Access Compliance Report

Intersection ID: 17196	Main Street: IDLEWILD_RD	Cross Street: CONFERENCE_DR	Location: NE
ADA ID: 1B81F8877FBB	Ramp Type: Perp	Initial Pass/Fail: Fail	Overall Compliance: No
Severity Score: 21.25			
Codes/Mitigation Info/Possible Solution		Field Measurements/Component Compliance

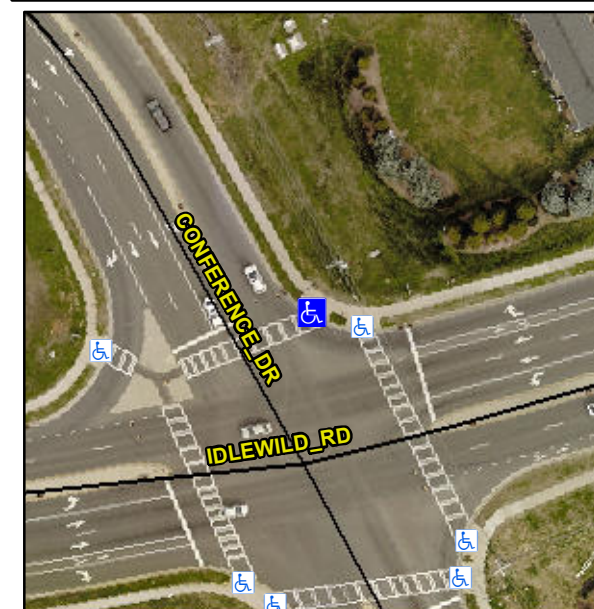
Not Found, R304.5.1, R304.2.2

Compliance	Description	Data	Compliance	Description	Data
N/A	Ramp Length (in)	66.0	No	Ramp Slope (%)	11.1
No	Ramp Width (in)	46.0	Yes	Ramp XSlope (%)	1.9
N/A	Flare Type LT	N/A	N/A	Flare Type RT	N/A
N/A	Flare Slope LT (%)	N/A	N/A	Flare Slope RT (%)	N/A
N/A	Flare Traversable LT?	N/A	N/A	Flare Traversable RT?	N/A
N/A	Landing Length (in)	N/A	N/A	DWS Provided?	N/A
N/A	Landing Width (in)	N/A	N/A	DWS Contrast?	N/A
N/A	Landing Slope (%)	N/A	N/A	DWS Length (in)	N/A
N/A	Landing X Slope (%)	N/A	N/A	DWS Full Width?	N/A
N/A	Landing Curb? (Y/N)	N/A	N/A	DWS Offset (in)	N/A
N/A	Shared Landing?	N/A			
N/A	Gutter Ponding?	N/A	N/A	Gutter Slope (%)	N/A
N/A	Gutter Lip Ht (in)	N/A	N/A	Gutter X Slope (%)	N/A
N/A	Painted X Walk1?	Yes	N/A	Painted X Walk2?	N/A
	X Walk 1 Direction	To SW		X Walk 2 Direction	N/A
N/A	X Walk 1 Width (in)	114.0	N/A	X Walk 2 Width (in)	N/A
	X Walk 1 Slope (%)	1.6		X Walk 2 Slope (%)	N/A
	X Walk 1 X Slope (%)	2.9		X Walk 2 X Slope (%)	N/A

Remove & Replace Entire Ramp.
